Westlake & Lenora Park

This was the Seattle Design Commission's (SDC) third review of the Westlake & Lenora Park. Prior to this meeting, the SDC reviewed and approved the concept design in 2014. The purpose of this meeting was to review the design development phase of the Westlake & Lenora Park development. After the presentation, questions, and deliberation, the SDC voted, 6-1, to approve the design development phase of the Westlake & Lenora Park development with several recommendations.

September 07, 2017

Design Development

Figure 1: Project site location (top) updated design proposal (bottom)

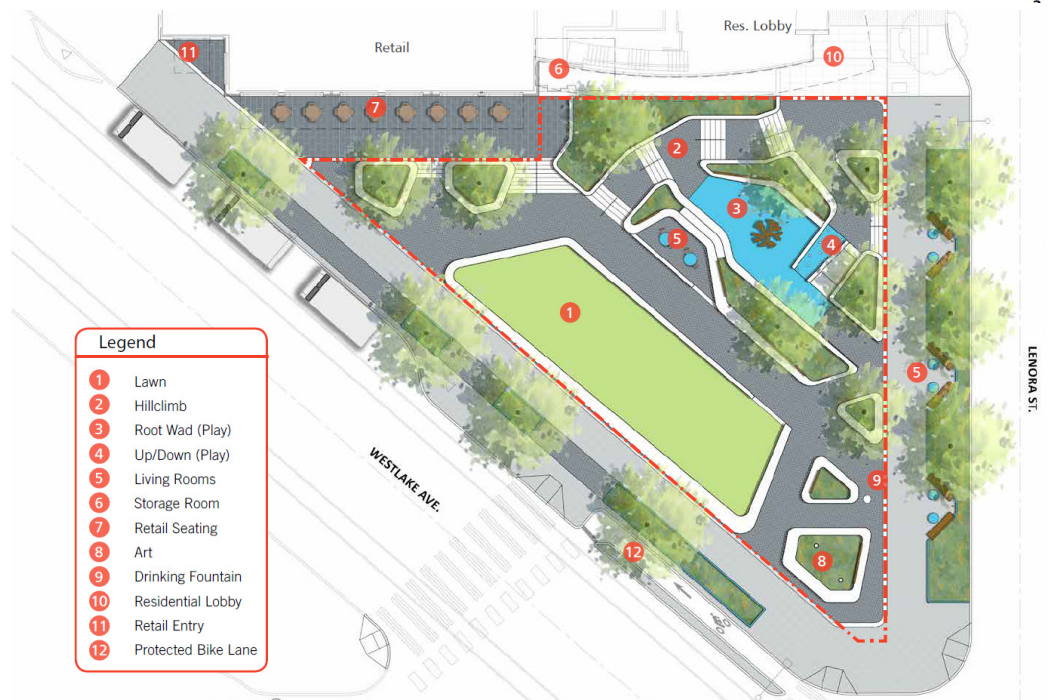
Although the SDC supported the overall programming for the proposed park, a few commissioners were concerned with the lack of integration between two programming elements, seating and recreation space. Commissioners recommended the design team simplify programming as well as to create a park center. The Commission complemented the design team for the complex design of the play area, which contrasts with the open lawn, but agreed there should be better interaction between the two areas.

The SDC was also concerned with the proposed wall on the interior side of the lawn, separating the lawn from the adjacent interior pathway. Commissioners recommended eliminating the wall to create a continuous open edge along

the pathway. The commission discussed sloping the lawn towards the interior pathway as a potential solution for eliminating the need for the interior wall.

The commission was concerned with the lack of a designated area for dogs. Commissioners worried that without a designated area, dogs will utilize several areas throughout the park. The Commission recommended the design team designate an area for dogs.

The SDC discussed the potential opportunity for placemaking near a park center. Commissioners then agreed the tree root play element has the potential to serve as a landmark within the park. The SDC then discussed narrowing the interior pathway to increase the width of the open lawn.

The SDC disagreed on the proposed concrete color. Several commissioners were concerned the concrete would easily stain and recommended using a darker shade. Other commissioners suggested the proposed concrete color increased the visual quality of the material and thought stains and markups were indicators of a well-used space. The Commission recommended the project team be more attentive to the contrast between proposed hardscape materials.

1. Consider simplification of the design and unification of the two disconnected halves of the park.
2. Consider eliminating the proposed wall on the interior of the lawn, opening the lawn to the adjacent interior walkway
3. Designate a location in one of the tree pits within the ROW for dogs
4. Reduce the amount of contrast between the hardscape materials throughout the site

Rachel Gleeson- The proposed program elements are not working together to achieve the intended concept.
